Re: **Letter of Wastewater Service Approval**  
Pilot Knob MUD No. 2 & 3: Easton Park Section 2C  
Utility Infrastructure Review for Wastewater (UIR-PK3-013)

Re: **Letter of Wastewater Service Approval**  
Pilot Knob MUD No. 3: Easton Park Section 2A  
Utility Infrastructure Review for Wastewater (UIR-PK3-007)

Re: **Letter of Wastewater Service Approval**  
Pilot Knob MUD No. 2 & 3: Easton Park Section 2B  
Utility Infrastructure Review for Wastewater (UIR-PK3-011)

**W.W. UIR Name: Easton Park Section 2A**

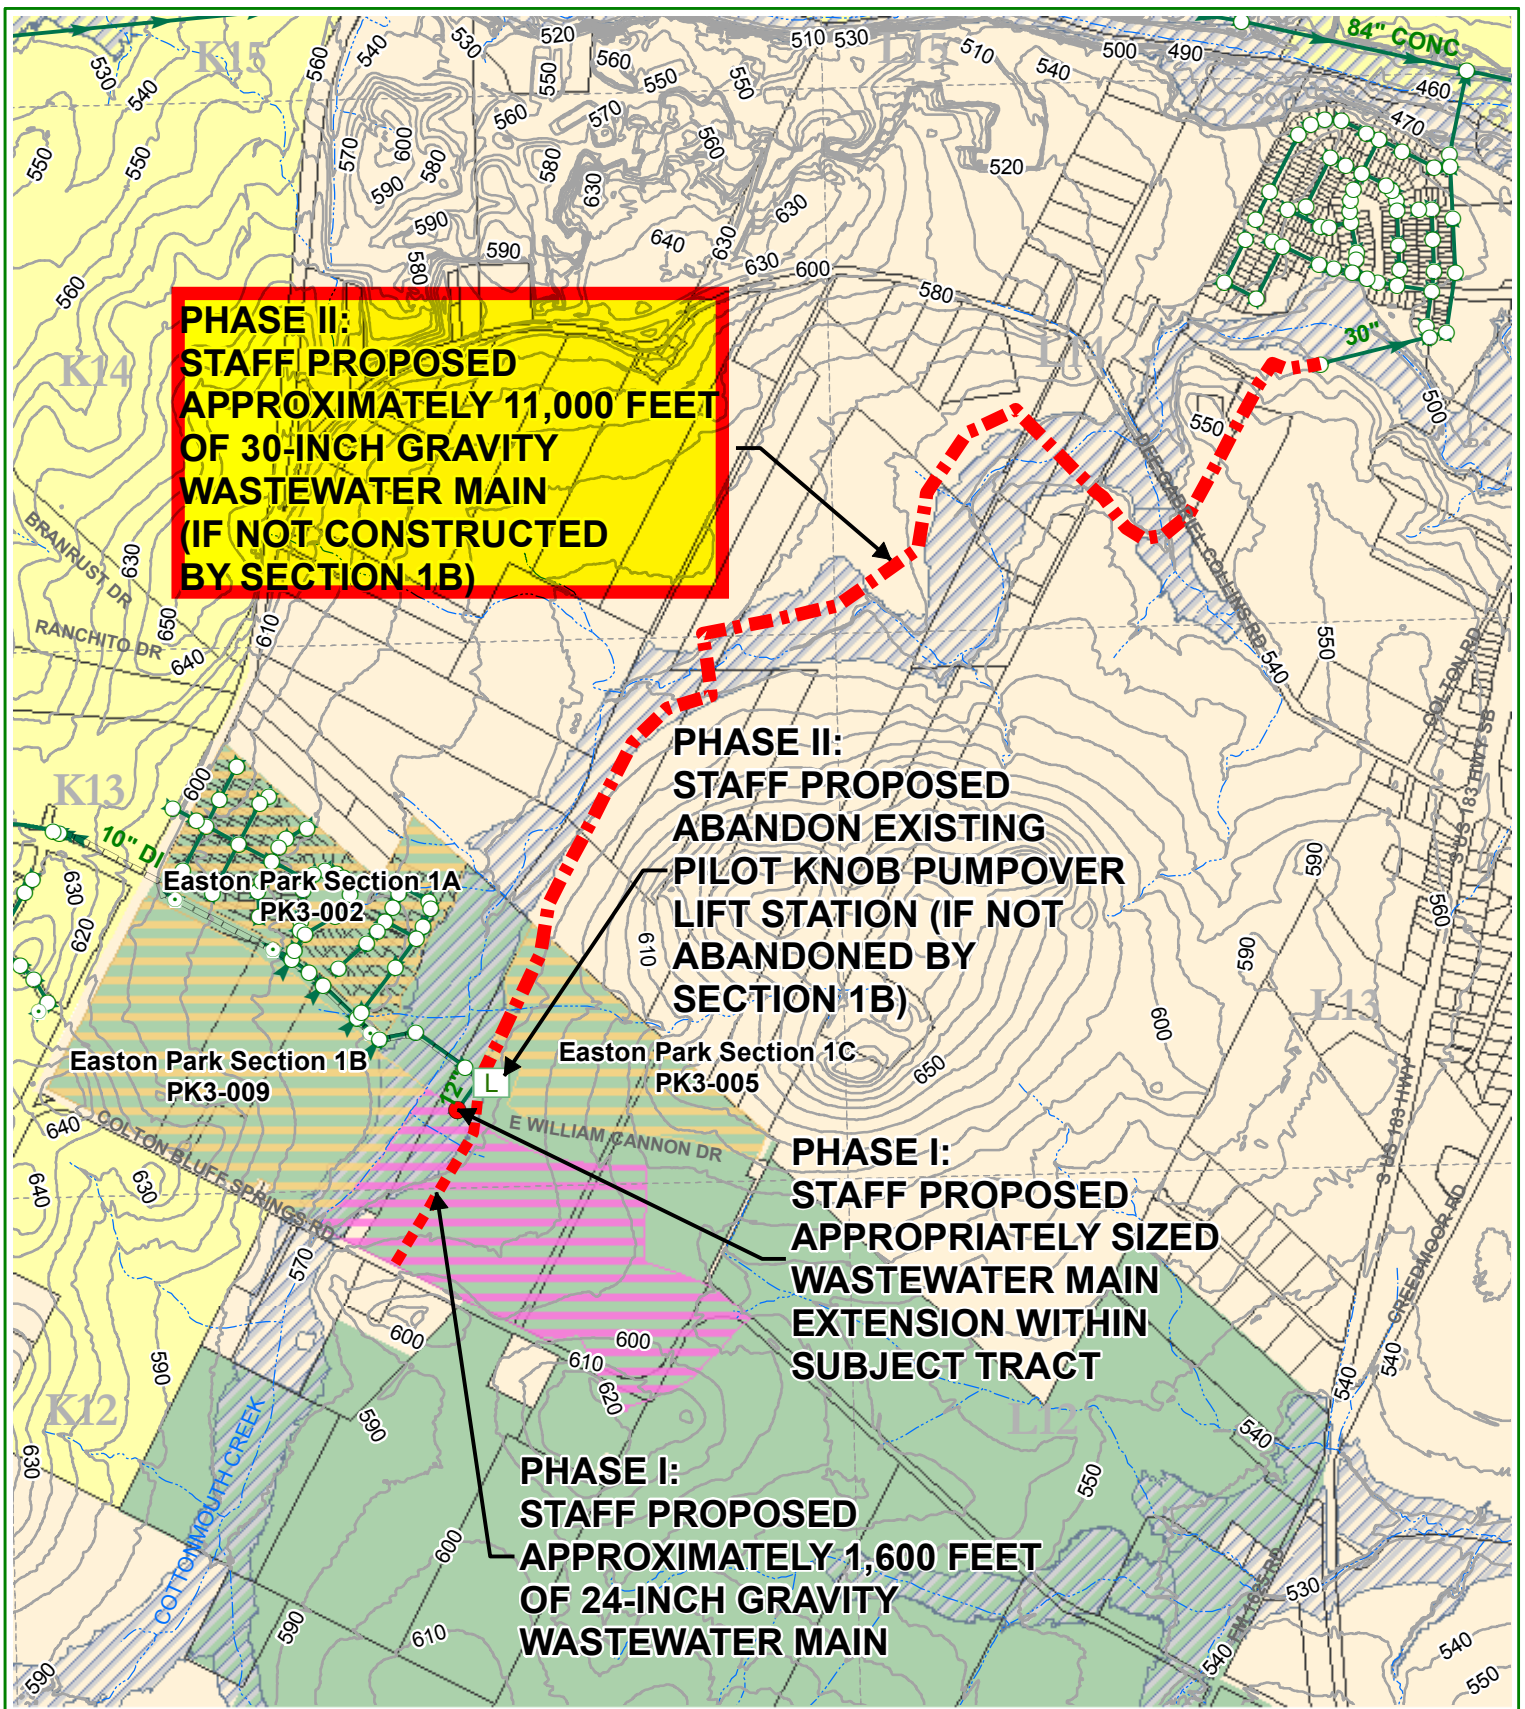
1. Construction of a minimum 8-inch gravity wastewater collection system within the subject tract.
2. Construction of approximately 1,600 feet of 24-inch gravity wastewater interceptor along Cottonmouth Creek between the existing PKPLS and Colton Bluff Springs Rd. This wastewater interceptor shall be designed at a depth that will allow future gravity wastewater service for the wastewater drainage basin on both sides of Cottonmouth Creek. **If the wastewater interceptor is not to be designed and constructed concurrently with the subdivision construction, then the Applicant shall dedicate an appropriately sized wastewater corridor for the interceptor. These wastewater improvements are also proposed by Easton Park Section 2B and 2C.**

1. Construction of approximately 11,000 feet of 30-inch gravity wastewater interceptor along Cottonmouth Creek from the existing 30-inch gravity wastewater interceptor located north of the subject tract and Dee Gabriel Collins Rd at Cottonmouth Creek (Project 2014-0616) and extending south to the downstream end of the proposed 24-inch gravity wastewater interceptor constructed under Phase I. **These wastewater improvements are also proposed by Easton Park Section 1B. If the Applicant's project timeline needs these improvements prior to construction of these improvements by others, then the design and construction of the improvements is the full responsibility of the Applicant.**

2. Abandonment of the PKPLS and force main and diversion of the wastewater flows from the lift station to the proposed 30-inch gravity wastewater interceptor. **These wastewater improvements are also proposed by Easton Park Section 1B. If the Applicant's project timeline needs these improvements prior to construction of these improvements by others, then the design and construction of the improvements is the full responsibility of the Applicant.**

**W.W. UIR Name: Easton Park Section 2B**  
**MUD Name: Pilot Knob MUD Nos. 2 & 3**  
**W.W. UIR Number: PK3-011**

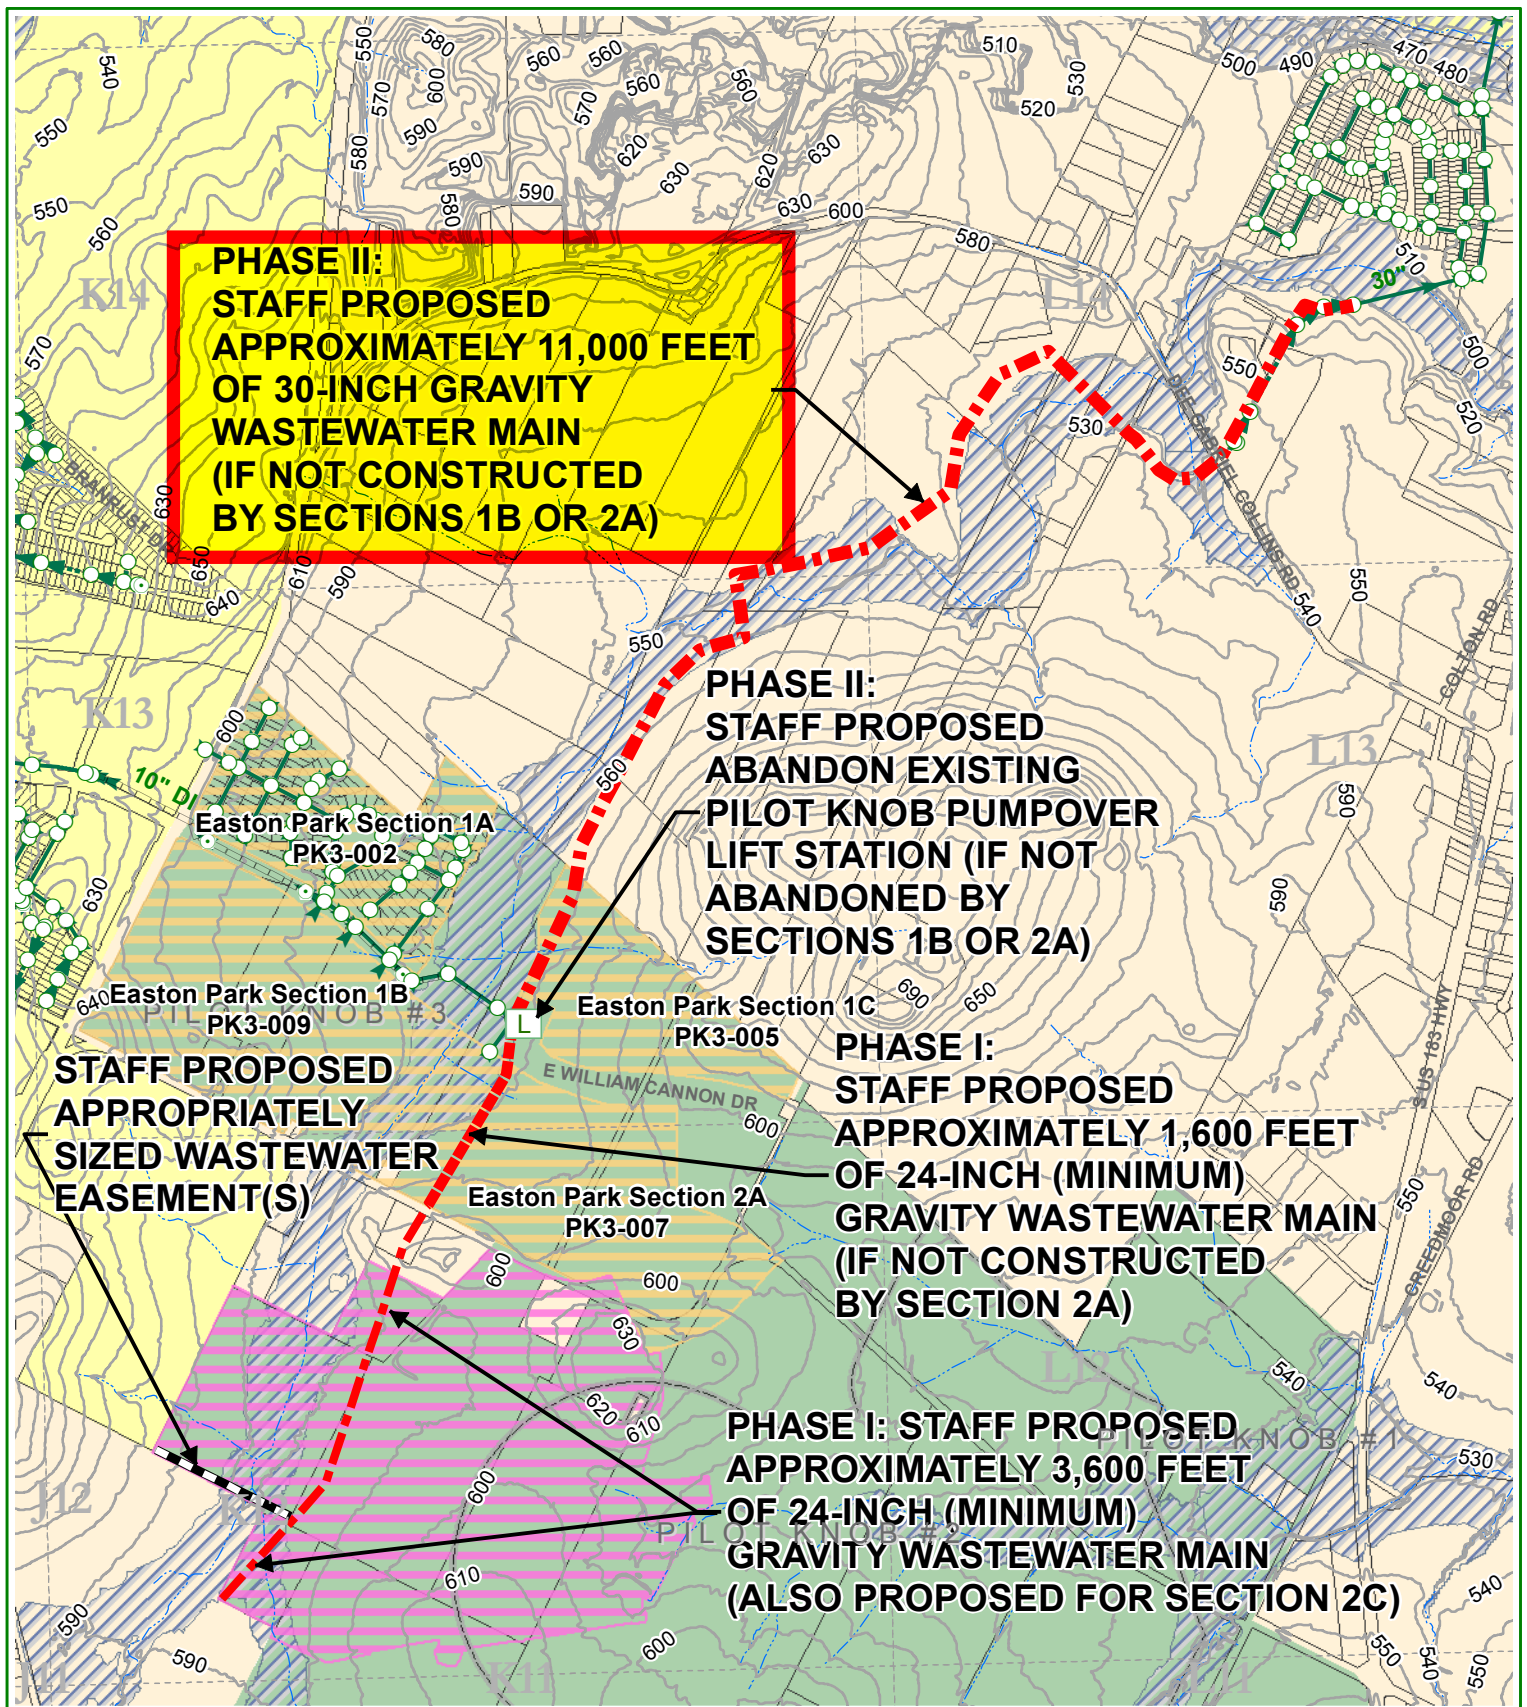
2. Construction of approximately 1,600 feet of 24-inch (minimum) gravity wastewater interceptor along Cottonmouth Creek between PKPLS and Colton Bluff Springs Rd (through Section 2A). **These wastewater improvements are also proposed by Easton Park Section 2A.**

3. Construction of approximately 3,600 feet of 24-inch (minimum) gravity wastewater interceptor from the proposed 24-inch gravity wastewater interceptor at Colton Bluff Springs Rd (item 2) and extending south along the main branch of Cottonmouth Creek through the subject tract. The wastewater interceptor may be constructed in phases as development of Sections 2B and 2C progresses, as approved by AW. **If the wastewater interceptor is not to be designed and constructed concurrently with the subdivision construction, then the Applicant shall dedicate an appropriately sized wastewater easement for the interceptor.**

4. The proposed 24-inch gravity wastewater interceptor (items 2-3) shall be designed at a depth that will allow future gravity wastewater service for the wastewater drainage basin on both sides of Cottonmouth Creek.
5. Dedication of appropriately sized wastewater easement(s) from the proposed 24-inch gravity wastewater interceptor within the subject tract (item 3) and extending west and south to the MUD boundary, as approximately shown on Exhibit M-4 of the Agreement.
6. Construction of an appropriately sized (minimum 8-inch) gravity wastewater collection system within the subject tract.
